81133A-01A

# S E R V I C E N O T E

## 81133A- High Speed Pulse Generator

Serial Numbers: DE42800001-DE42800314

MOTHERBOARD  
BACK SIDE VIEW

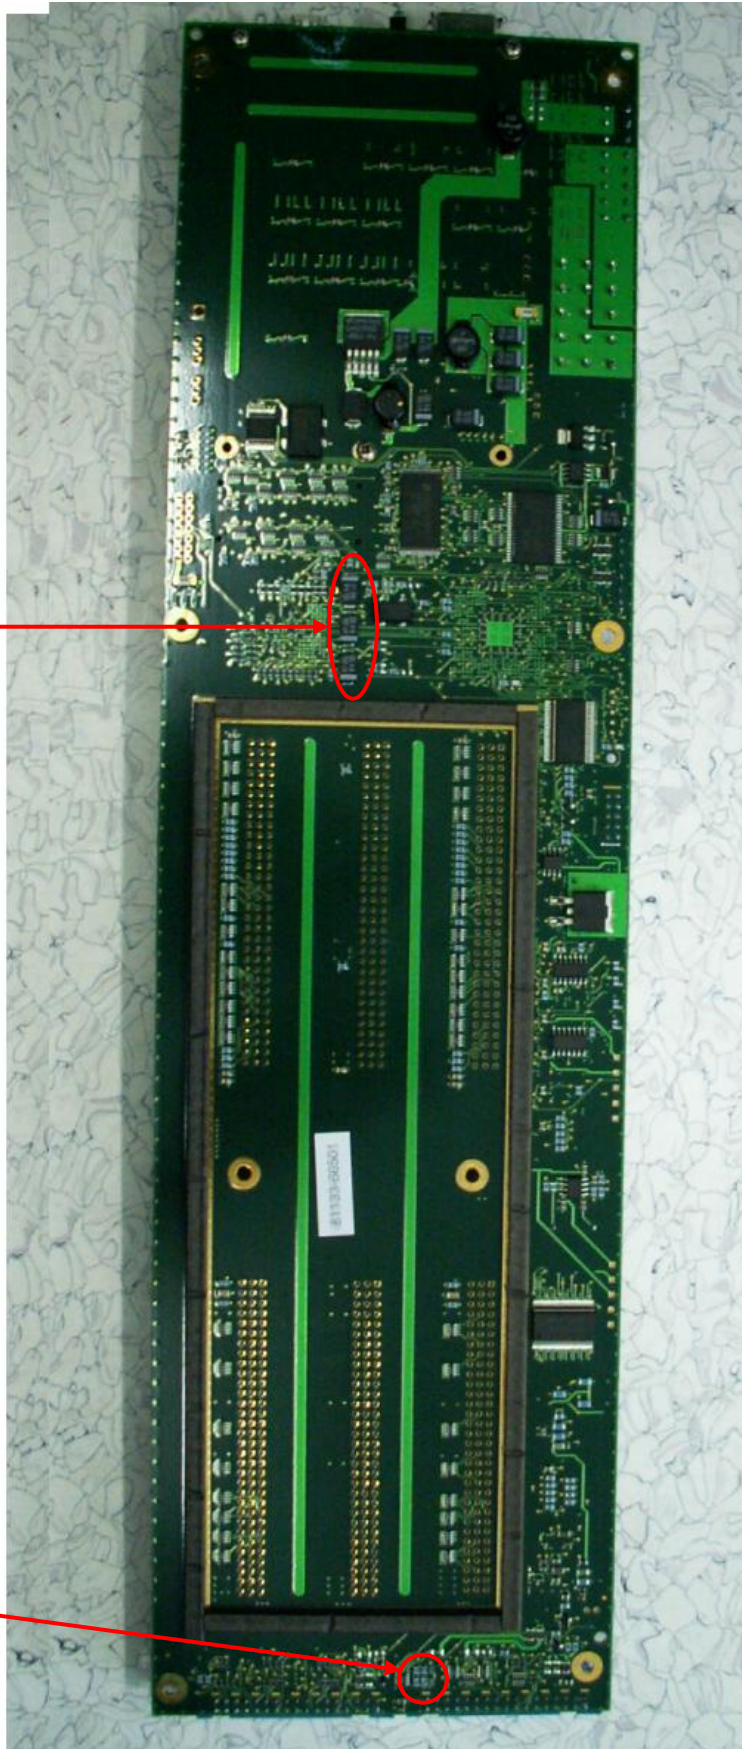
The preventive maintenance to avoid flickering display failures requires removing the 3 capacitors shown in the following picture. And replacing them with new capacitors (part number 0180-4758) while mounting them with the correct polarity.

Polarized Capacitors

Extra Resistors

CLOSE UP VIEW WHERE THE CAPACITORS ARE LOCATED

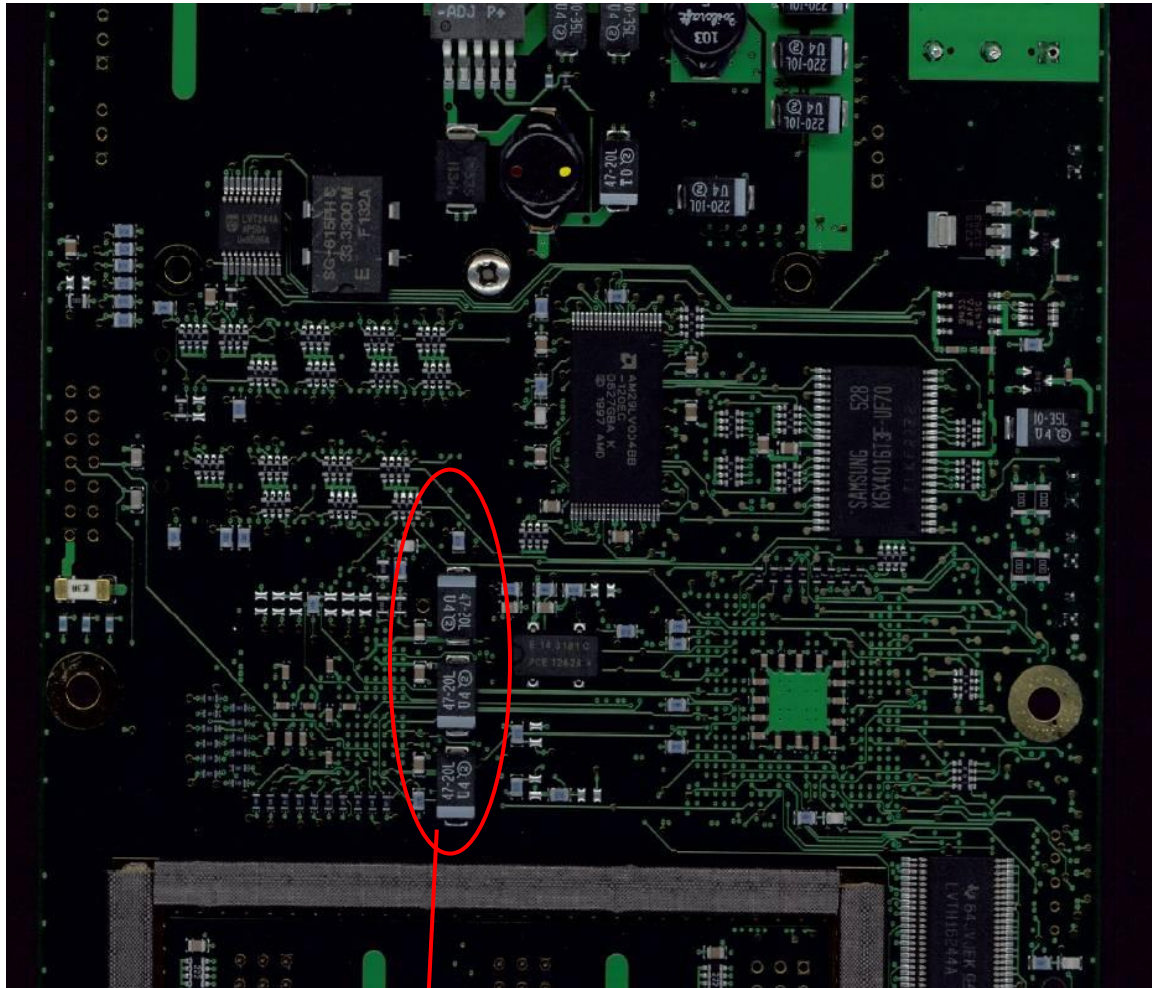
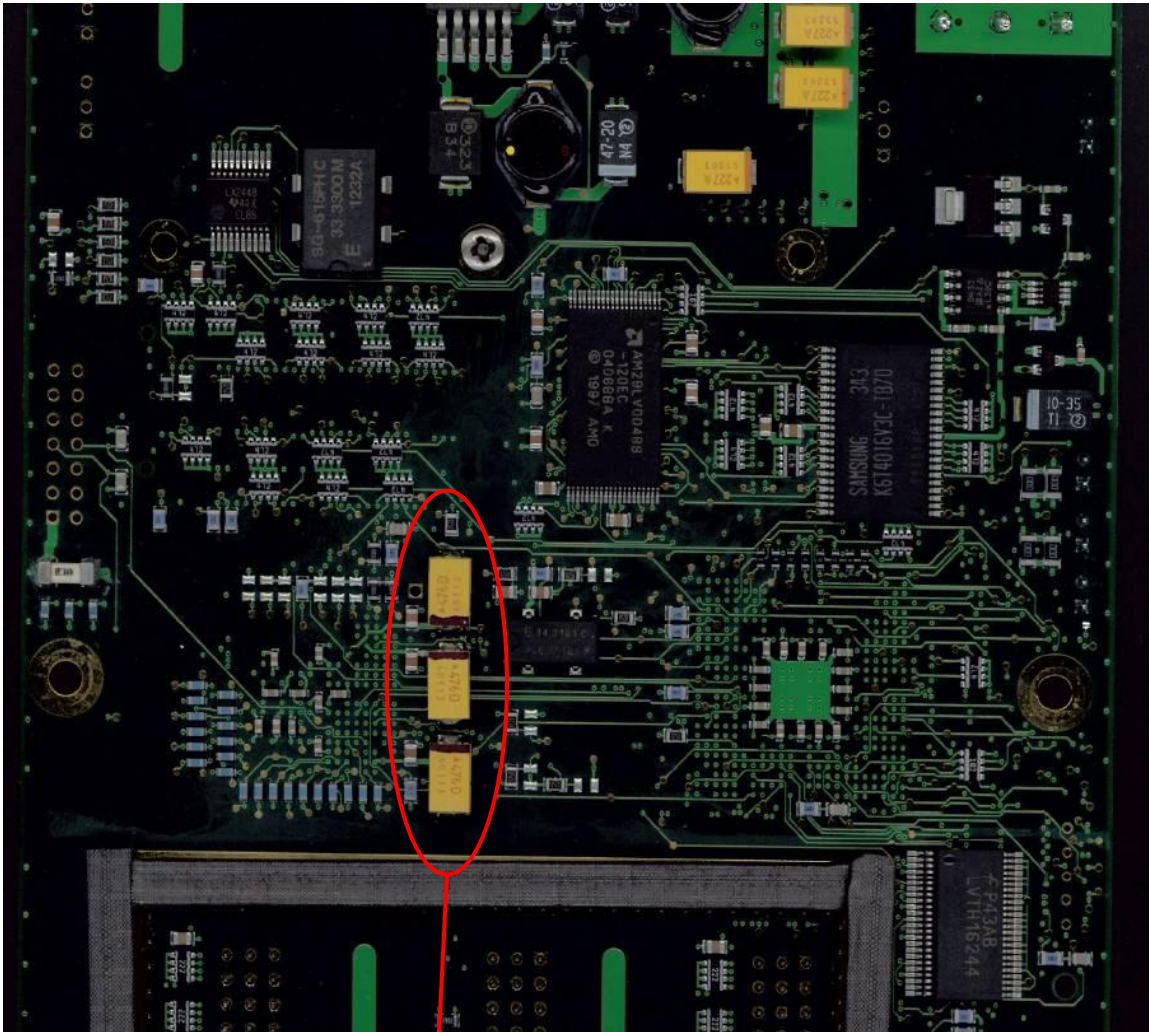
Three polarized tantalum capacitors on the motherboard are connected with the wrong polarity. The polarized tantalum capacitors are normally more sensitive than others, so they tend to fail after some months. Due to this, wrong voltages were delivered to the front panel board which in turn affected the display.

Capacitors mounted with the wrong polarity. The positive side is shown with the white/grey stripe. These 3 capacitors need to be removed.

The capacitors are best removed using hot air. The new capacitors need to be mounted using standard soldering equipment.

This photo shows the capacitors mounted with the right polarity. The positive side is shown with the black stripe. The colors might vary.

CLOSE UP VIEW – THE RESISTORS ARE REMOVED

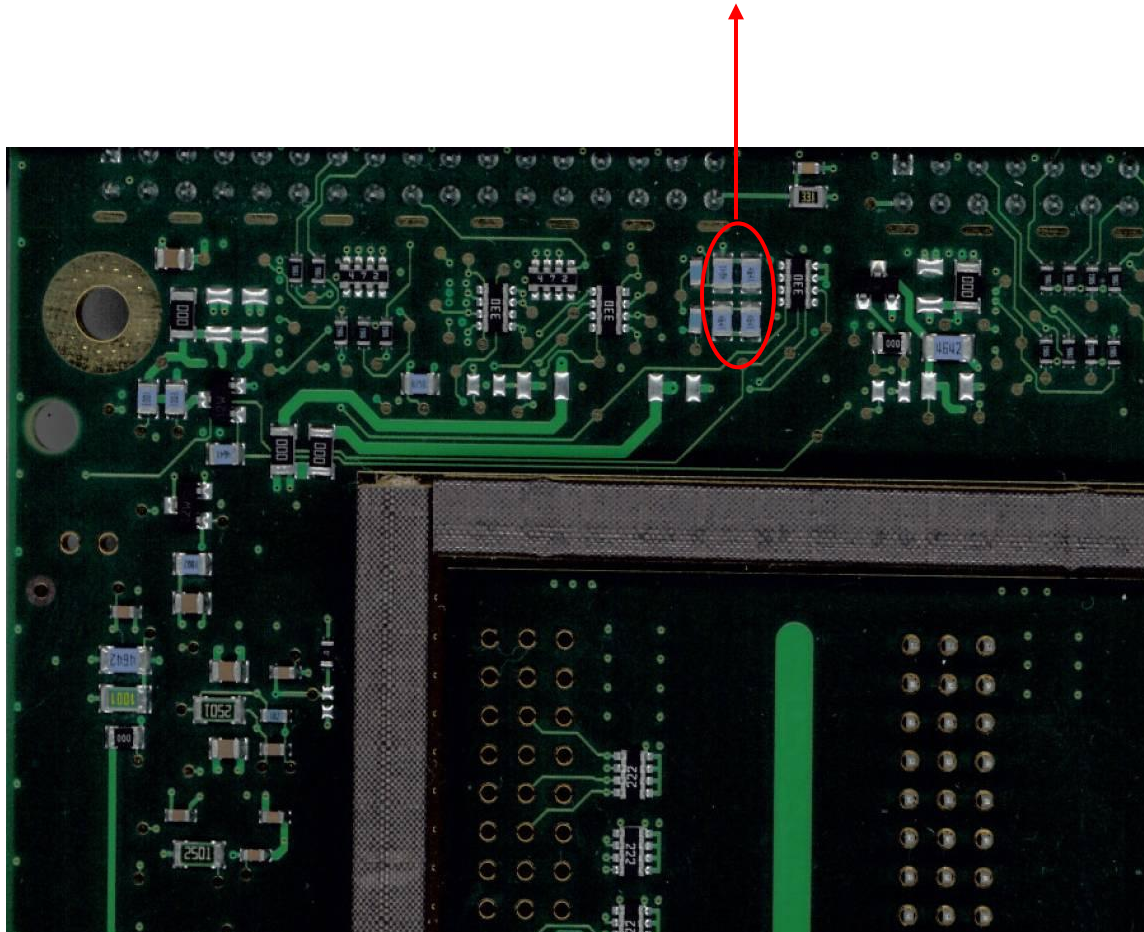
The rotary encoder (APN 0960-1055) has failed in some cases due to incorrect pull up resistance of the encoder. The pull-up resistance of this encoder as specified by the manufacturer is minimum 2.2 K Ohms. According the schematic of the front panel in the 81134A, the pull-up resistance used was 1.5 K Ohms. The lesser resistance value had possibly led to the flow of more currents into the encoder and had degraded the performance of it over a period of time.

For the preventive maintenance of the know problem the following 4 resistors need to be removed. They are best removed using hot air.

Resistors to be removed ( The colours can be different)

By removing a few parallel resistors the resistance can be increased, preventing failures of the rotary encoder in the future.

The place where the 4 resistors are removed
